"RAINBOW"

SERVICE LETTER RB-11

Service Letter 11-06

Service Bulletin

Bulletin No: Rainbow Service

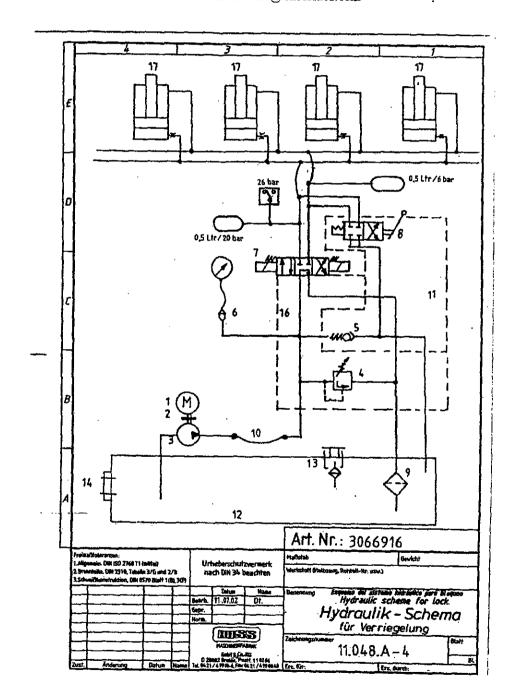
Following a review of the ride's safety system we are now of the opinion that the ride's safety system could be significantly improved with the installation of seat belts, moulded rubber seat inserts and the installation of a hydraulic pressure switch to monitor restraint system pressure.

- I. A pressure switch and nitrogen accumulator system should be installed in the gondola's electrical circuit and set to a minimum of 26 Bar to ensure that the ride cannot be started without the minimum hydraulic pressure.
- 2. Lap belts should be installed on each bench seat.
- 3. Moulded foam rubber seat inserts should be installed on each bench seat to minimize guests sliding from side to side.
- 4. The gondola's hydraulic restraint system pressure should be checked on a monthly basis to ensure that it is exerting a minimum of 30 Bar of pressure and the testing of the pressure should be documented in the attractions ride log book on a regular basis.
- 5. In addition, consideration should be given to installing gates on the gondola. A gondola retrofit package is available from the Huss Service department as an option; see Service Letter circa January 1990.
